**INDUSTRIAL DRIVE ATHLETIC FIELDS AND
DAWSON RECREATION IMPROVEMENTS
HOLDEN, MA**

ADDENDUM NO. 4

CONSTRUCTION DOCUMENTS

March 8, 2024

Sheet Number: **UT500**

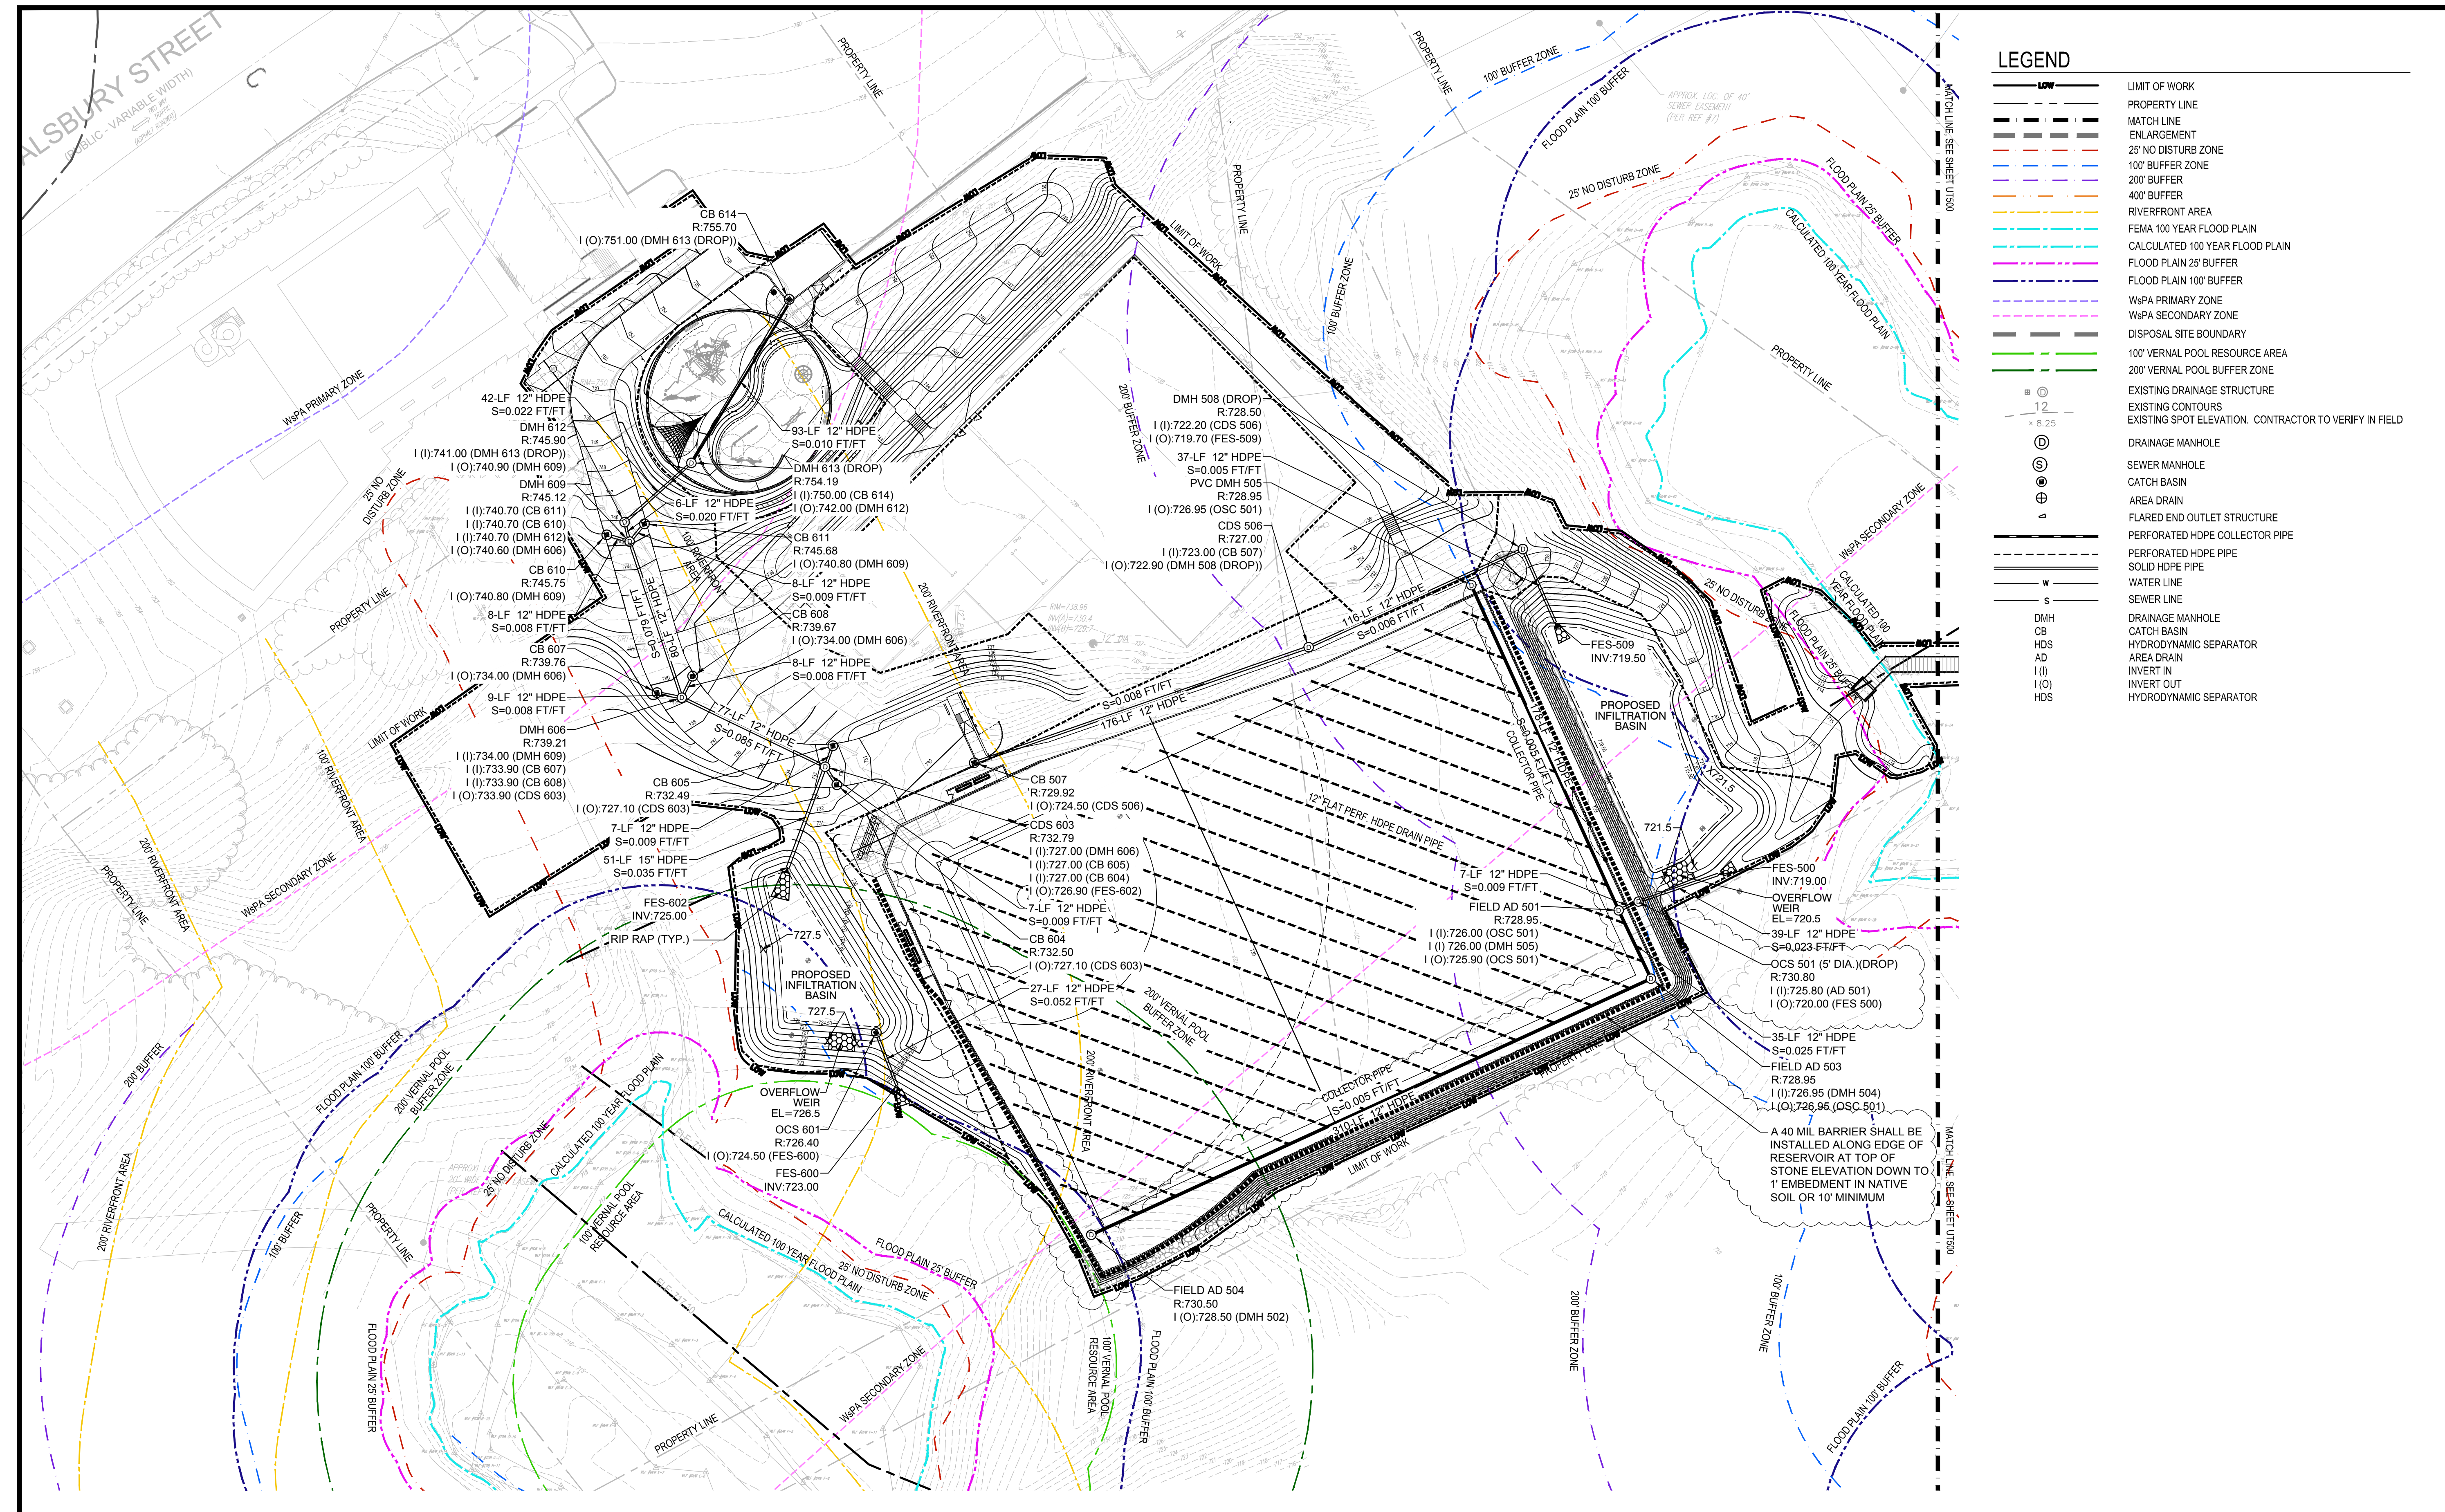
1. **DELETE:** Sheet UT500 – DRAINAGE & UTILITIES PLAN INDUSTRIAL DRIVE

Question 5: *L301 calls out a hydrant at the corner of the concrete pad by the support building but UT500 doesn't show any connection to it and there's no detail.*

Question 12: *Is the “Proposed Basin” closest to Industrial Dr on UT500 an “Infiltration Basin” per 5/UT701?*

ADD: Sheet UT500 – DRAINAGE & UTILITIES PLAN INDUSTRIAL DRIVE, per attachment.

Response: Contractor shall refer to Sheet UT500 -DRAINAGE & UTILITIES PLAN INDUSTRIAL DRIVE and Sheet UT702 – DRAINAGE & UTILITIES DETAILS, per attachment

Sheet Number:
UT501

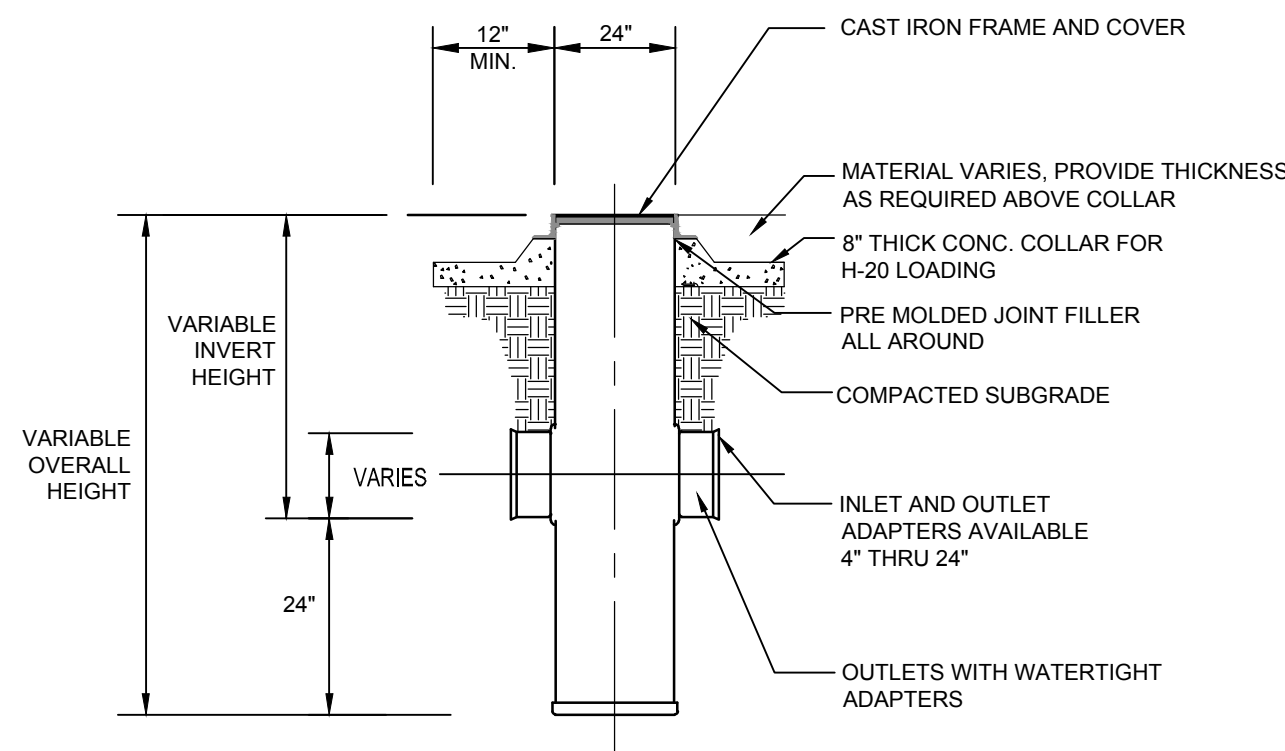
2. **DELETE:** Sheet UT 501 – DRAINAGE & UTILITIES PLAN DAWSON RECREATION

Question 8: *What are the limits of the impermeable barrier at the Baseball field(5/L705)? Limits are shown on UT500 but not UT501.*

ADD: Sheet UT 501 – DRAINAGE & UTILITIES PLAN DAWSON RECREATION, per attachment.

Response: For Clarification, refer to Sheet UT501 – DRAINAGE & UTILITIES PLAN DAWSON RECREATION, per attachment.
